**PERMIT AMENDMENT APPLICATION
PART III – SITE DEVELOPMENT PLAN
ATTACHMENT 5**

**MESQUITE CREEK LANDFILL
NEW BRAUNFELS,
COMAL AND GUADALUPE COUNTIES, TEXAS
MSW PERMIT NO. 66B**

Revised ~~→~~ 11 February 2010, 24 February 2021

PROJECT NO.: GT3435-03	DRAWN BY: JJV	REVIEWED BY: BAG	PART NO. III	FIGURE NO. 5-1
FILE NO.: 3435-058	CHECKED BY: SMG	APPROVED BY: JLRM

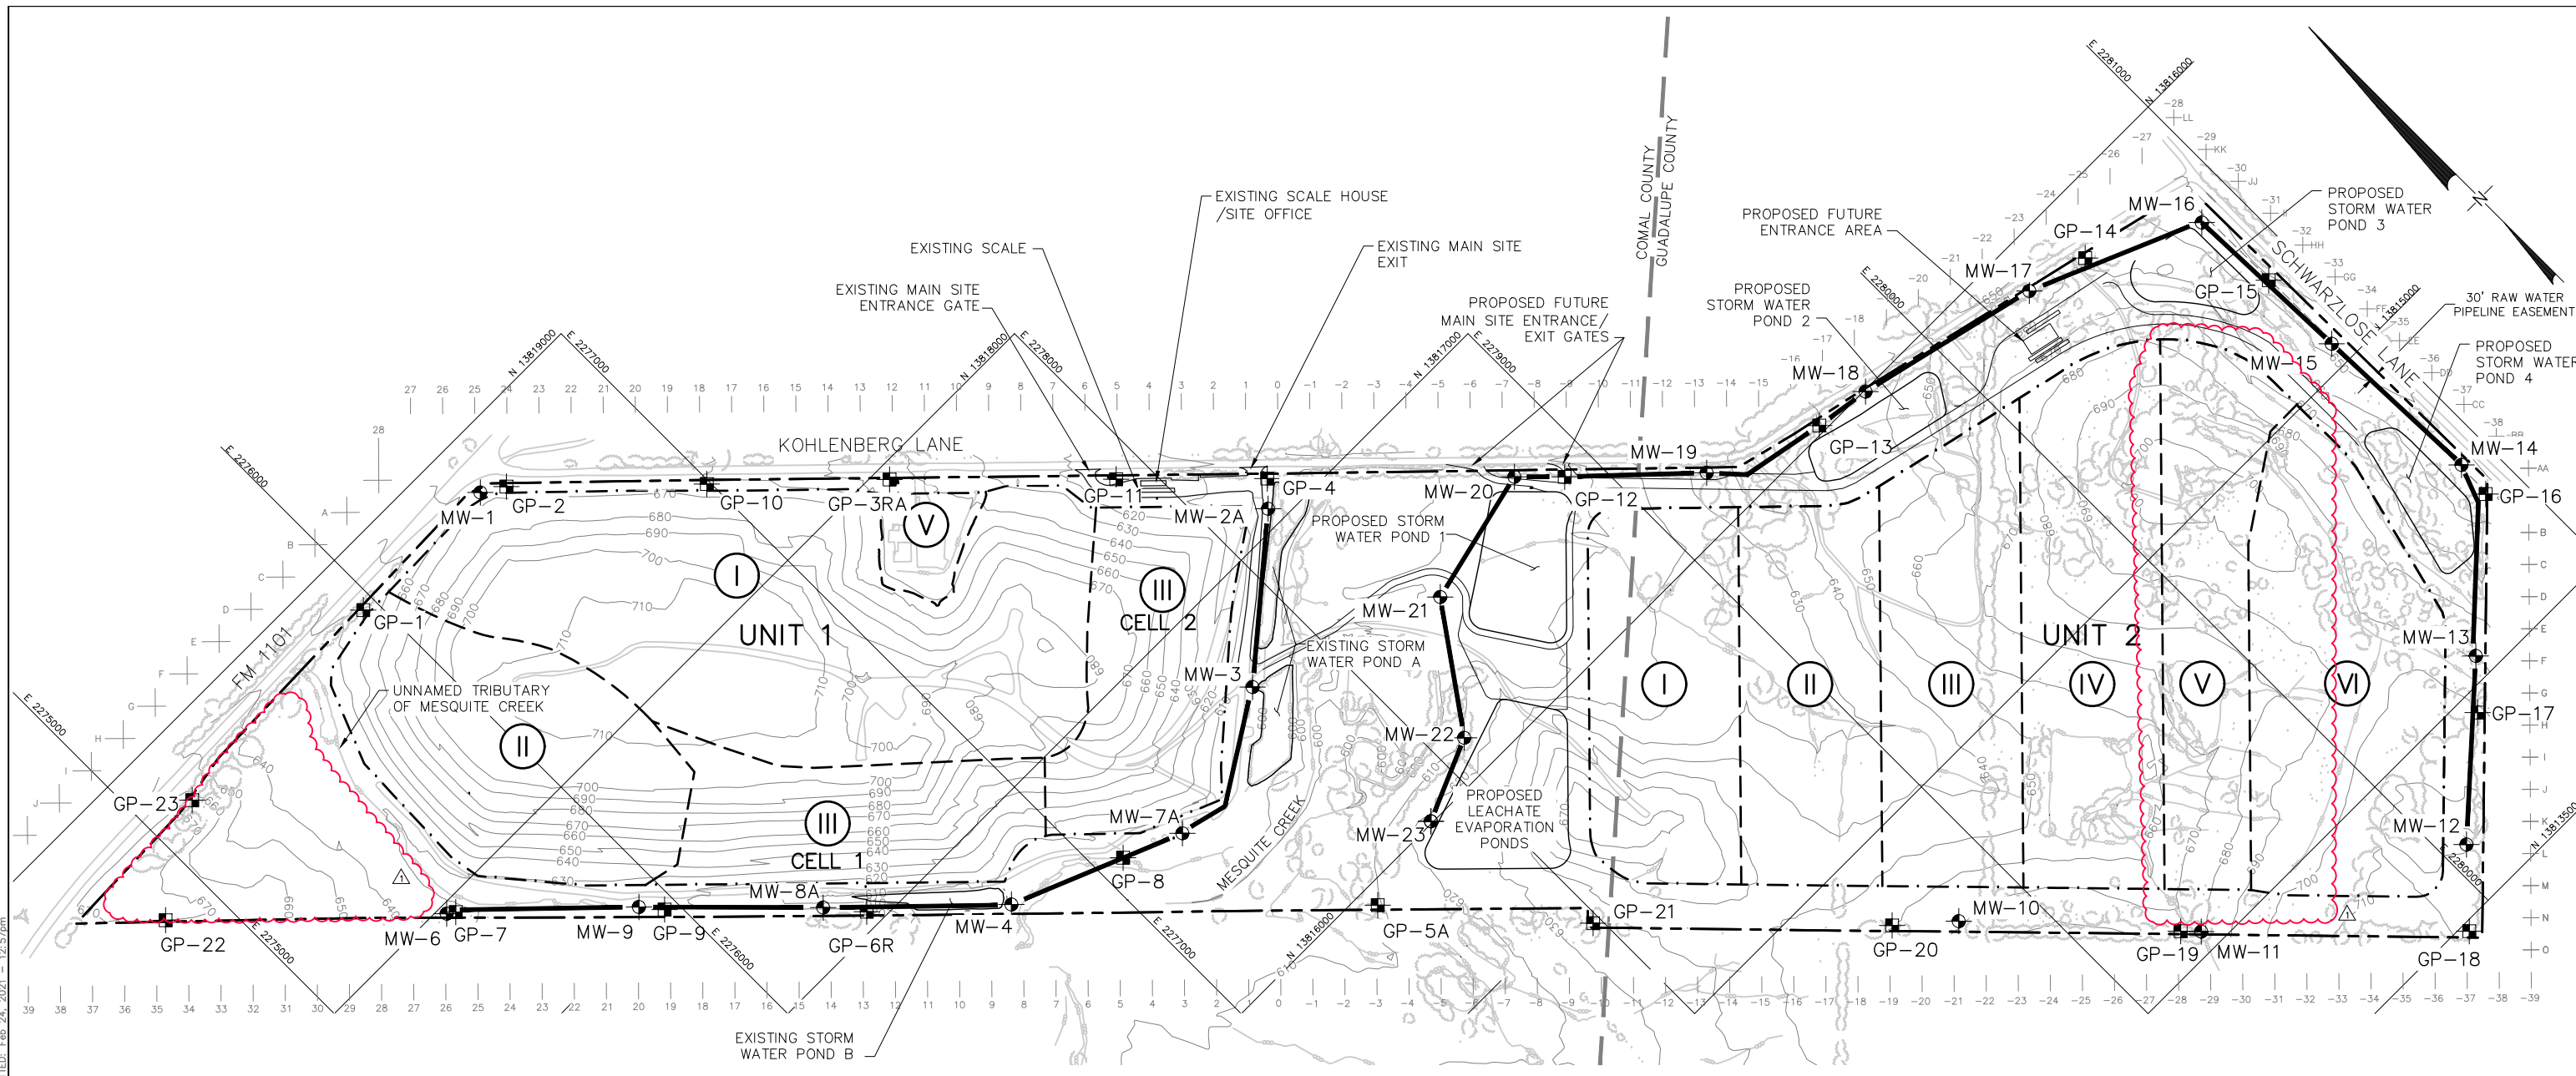
MARK	DATE	REVISION	ENGINEER	BY	APPROVED
△	02/24/2021	ELIMINATE UNIT 3	JJV		MW
-	07/14/2006	TECHNICALLY COMPLETE	SMG		JLRM
-	05/15/2006	RESPONSE TO NOD 2	SMG		JLRM
-	03/28/2006	RESPONSE TO NOD 1	SMG		JLRM
-	11/18/2005	INITIAL SUBMITTAL TO TCEQ	-		-

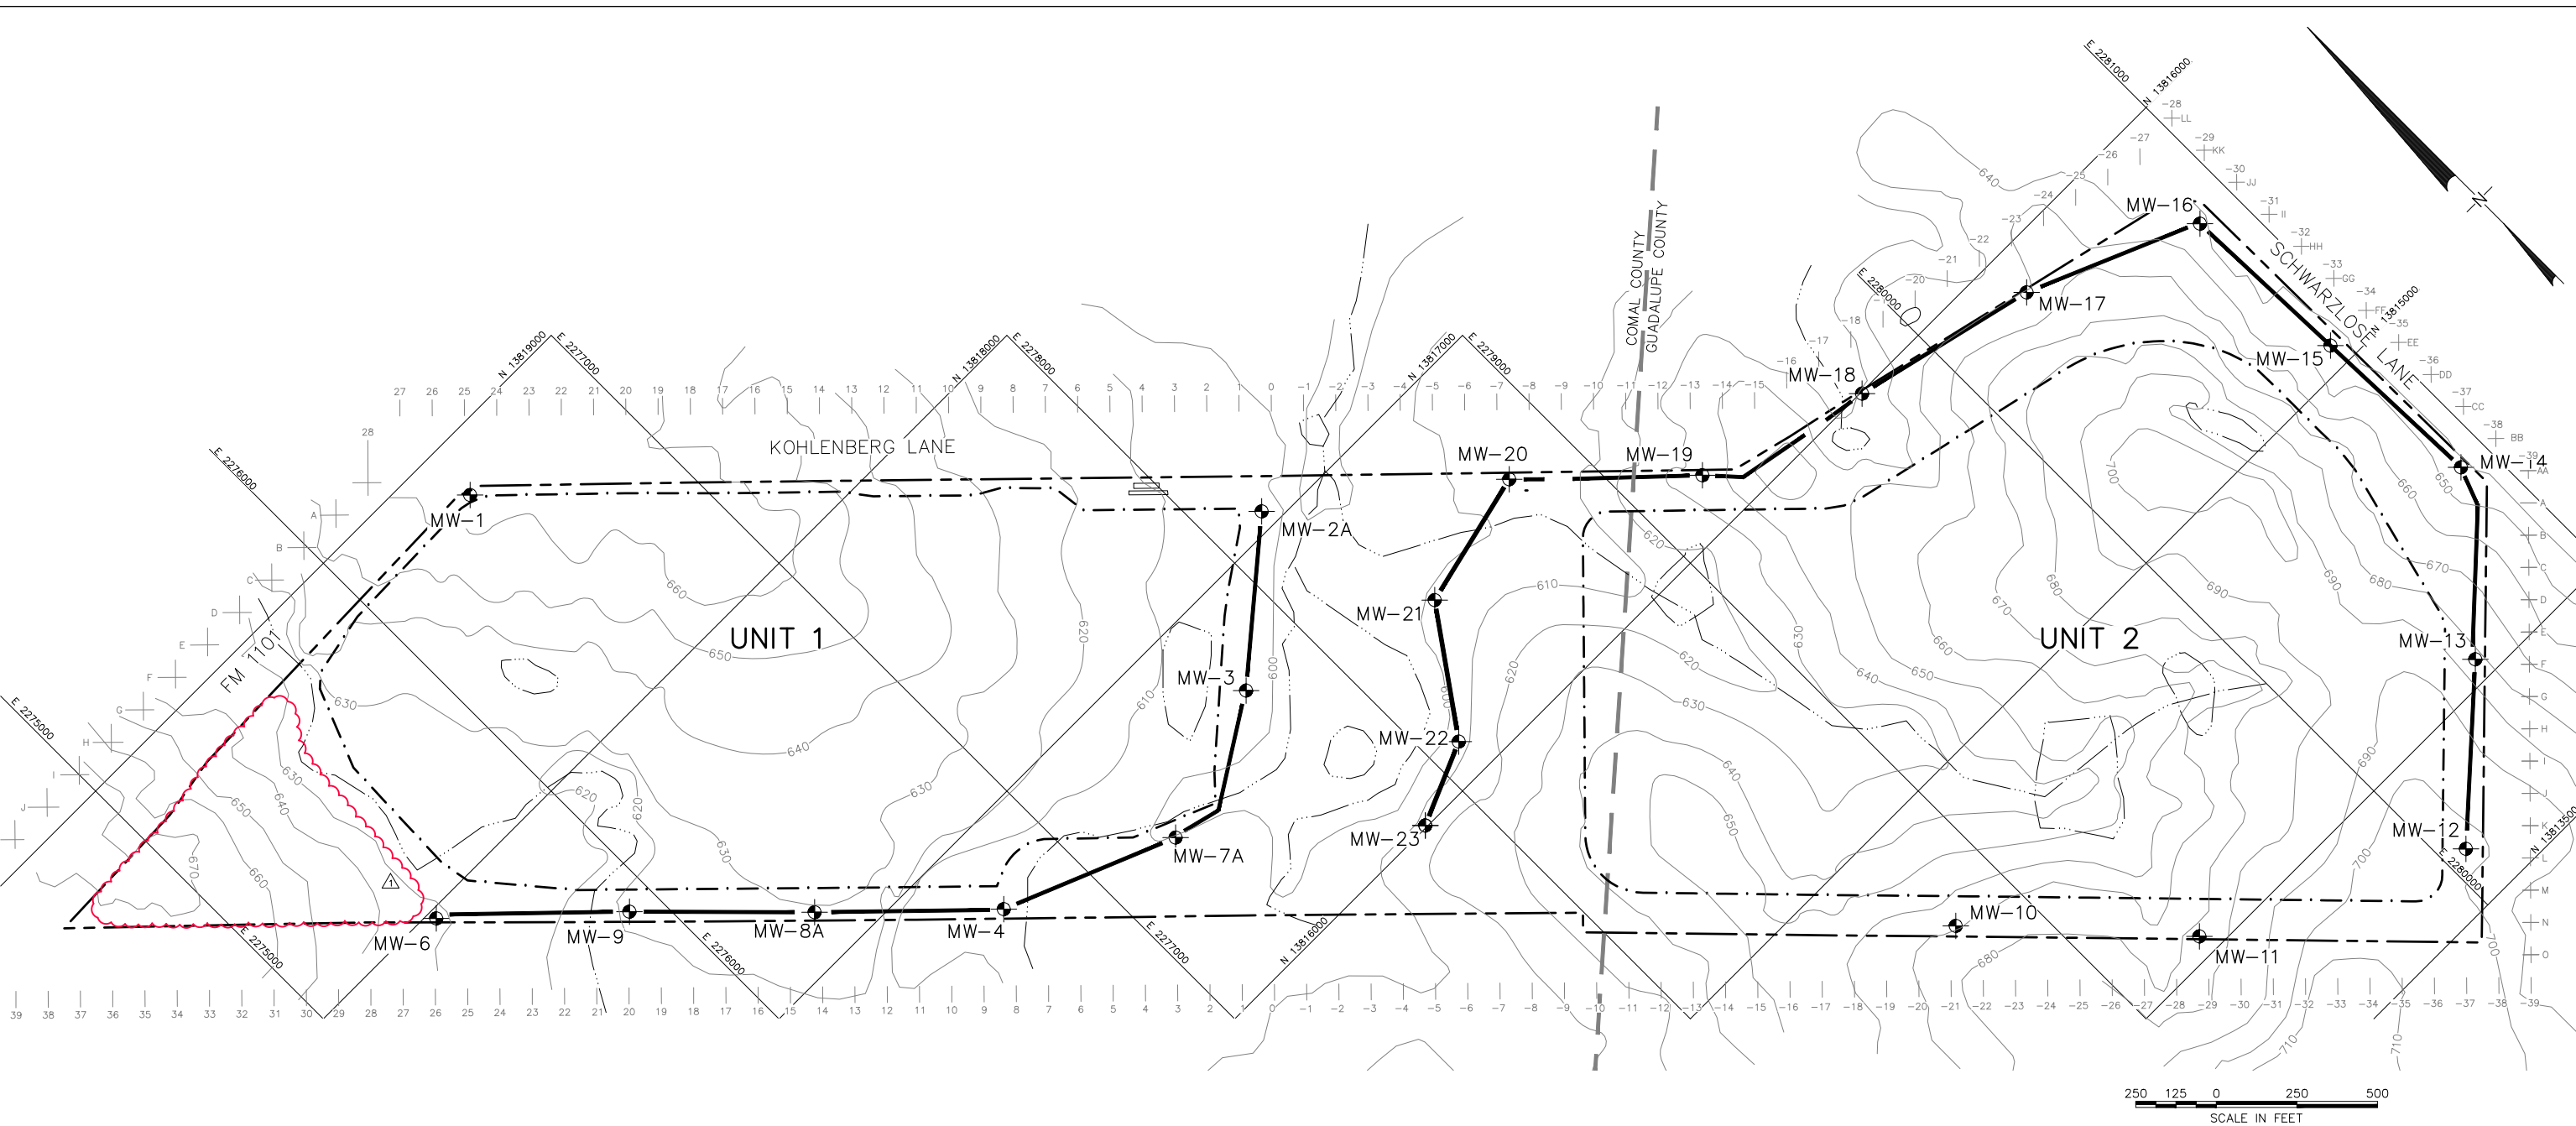
▲	02/24/2021	ELIMINATE UNIT 3	JVV	MW
-	07/14/2006	TECHNICALLY COMPLETE	JLRM	JLRM
-	05/15/2006	RESPONSE TO NOD 2	JLRM	JLRM
-	03/28/2006	RESPONSE TO NOD 1	JLRM	JLRM
MARK	DATE	REVISION	BY	APPROVED
OWNER / SITE ADDRESS:			ENGINEER:	
		WASTE MANAGEMENT OF TEXAS, INC. 1000 KOHLENBERG LANE P.O. BOX 311657 NEW BRAUNFELS, TEXAS 78130 (830) 685-7894		
		TEXAS PROF. GEOSCIENTISTS FIRM REGISTRATION NO. 50256 8217 SHOAL CREEK BLVD., SUITE 200 AUSTIN, TEXAS 78757 (512) 451-4003		
PROJECT: MESQUITE CREEK LANDFILL PERMIT APPLICATION - PERMIT NO. MSW - 66 B				
TITLE: PROPOSED GROUNDWATER MONITORING NETWORK WITH PRE-LANDFILL DEVELOPMENT TOPOGRAPHY				
PROJECT NO.:	GT3534-03	DRAWN BY:	JVV	REVIEWED BY:
FILE NO.:	3435-065	CHECKED BY:	SMG	APPROVED BY:
				JLRM
PART NO.	III			FIGURE NO.:
				5-1A

PROJECT NO.: GT3435-03	DRAWN BY: JJV	REVIEWED BY: BAG	PART NO. III	FIGURE NO. 6-1
FILE NO.: 3435-057	CHECKED BY: SMG	APPROVED BY: SMG

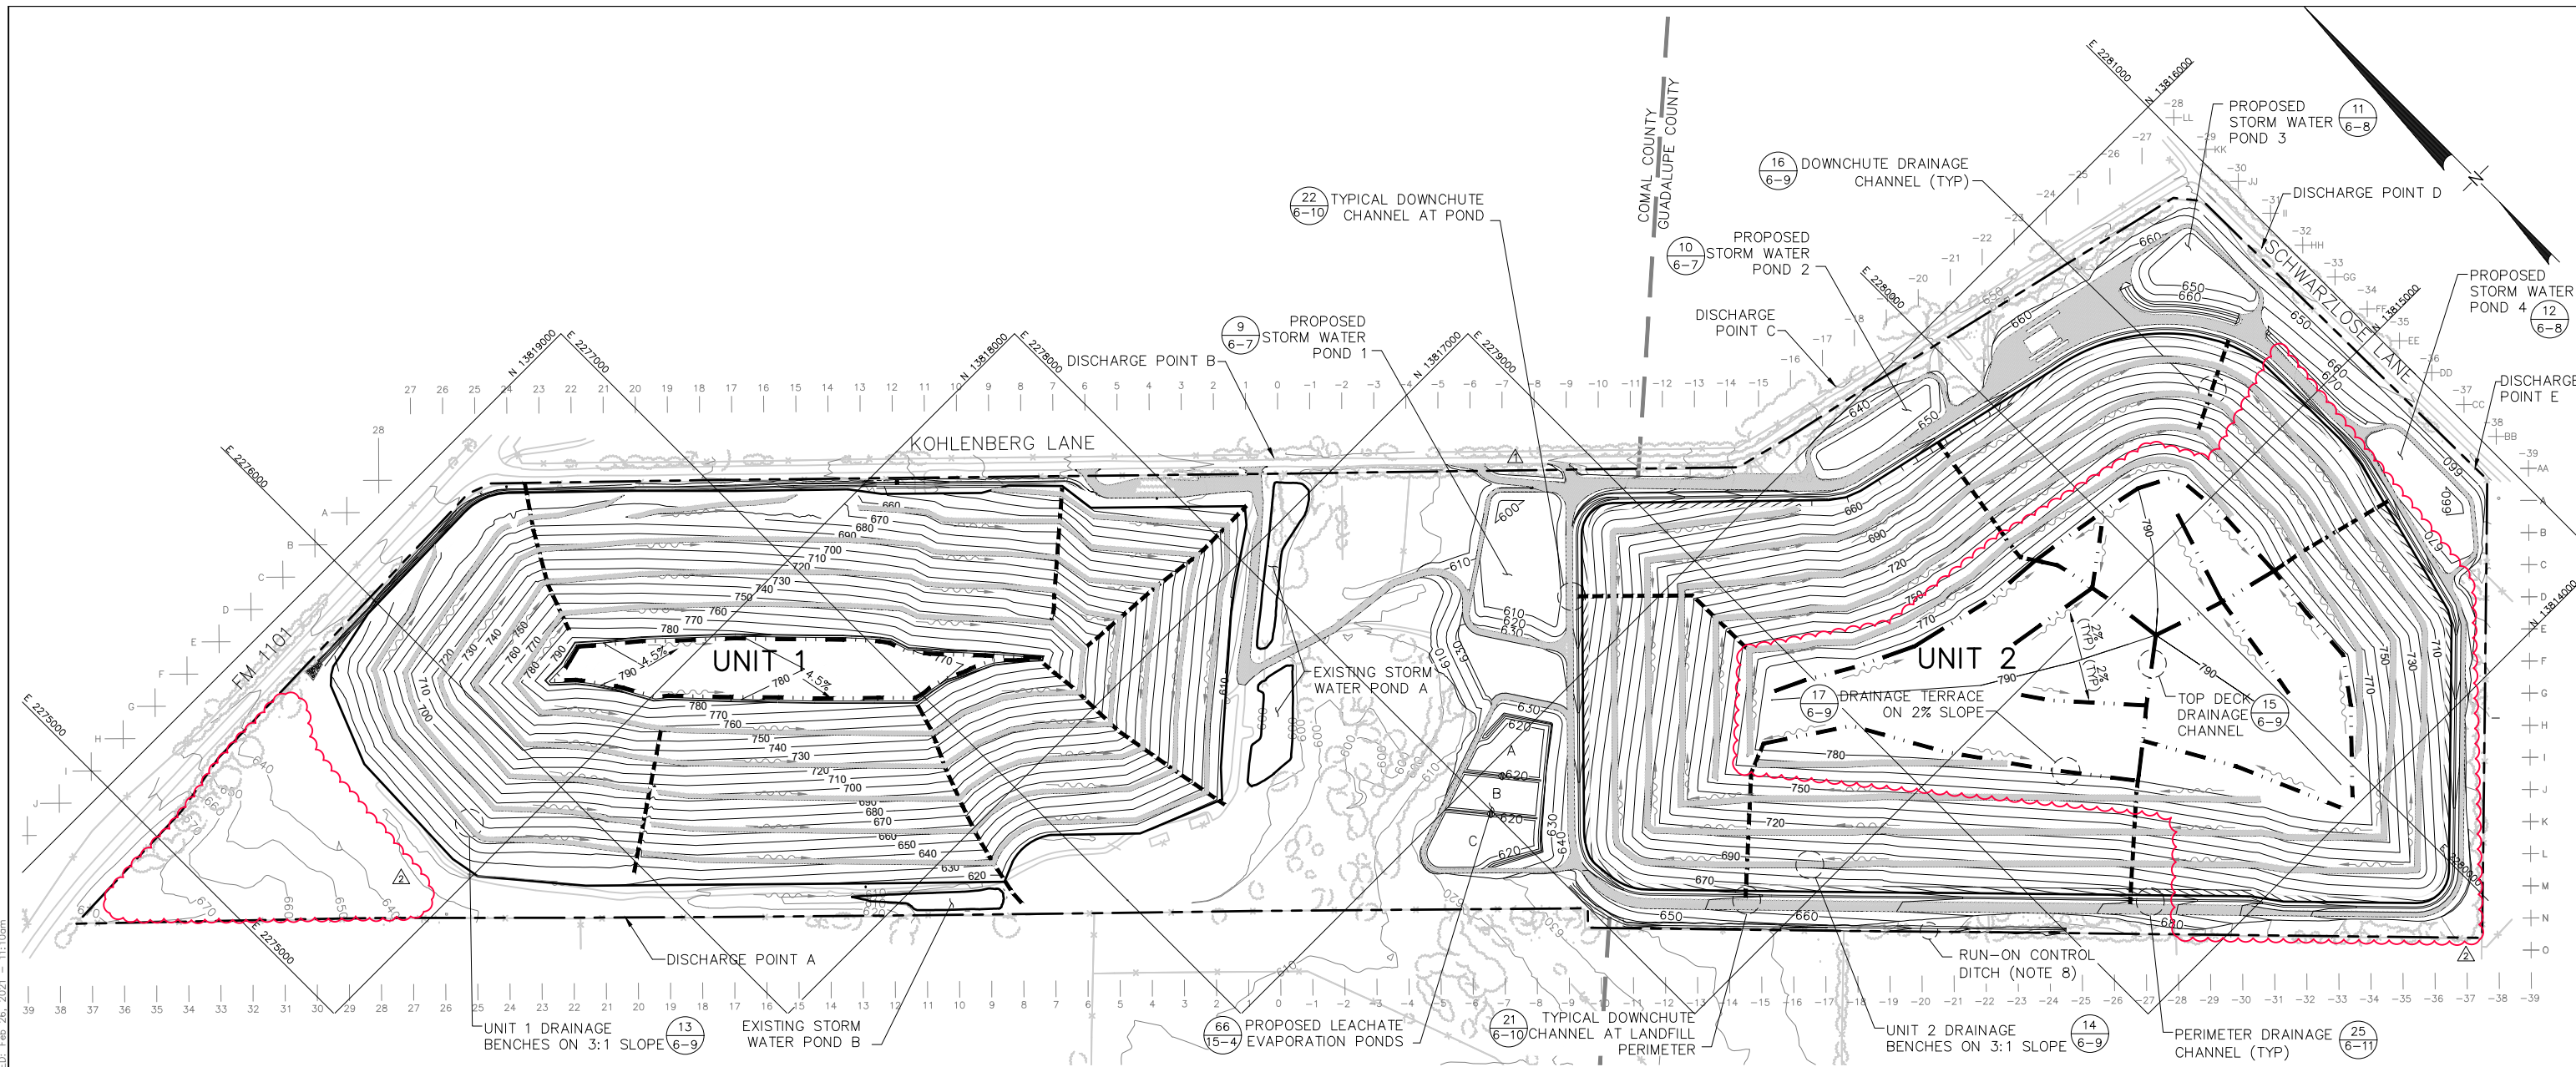
MARK	DATE	REVISION	BY	APPROVED
△	02/24/2021	ELIMINATE UNIT 3	JJV	SMG
△	08/08/2008	REVISED SITE ENTRANCE	SMG	SMG
-	07/14/2006	TECHNICALLY COMPLETE	SMG	SMG
-	03/28/2006	RESPONSE TO NOD 1	SMG	SMG
-	11/18/2005	INITIAL SUBMITTAL TO TCEQ	SMG	SMG

UNIT 3 PERIMETER DRAINAGE CHANNEL PROFILE
STATION 0+00 TO STATION 20+02.32

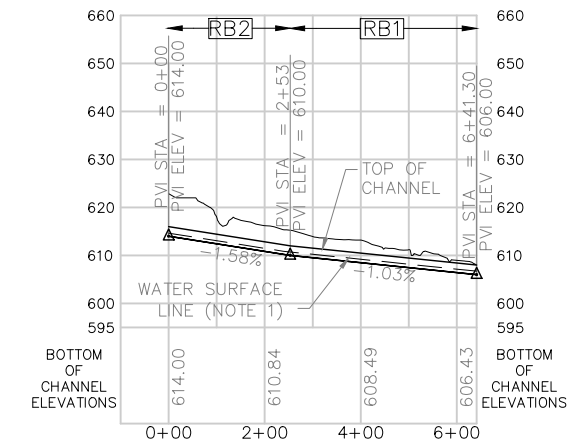
NOTE: UNIT 3
ELIMINATED IN
2021
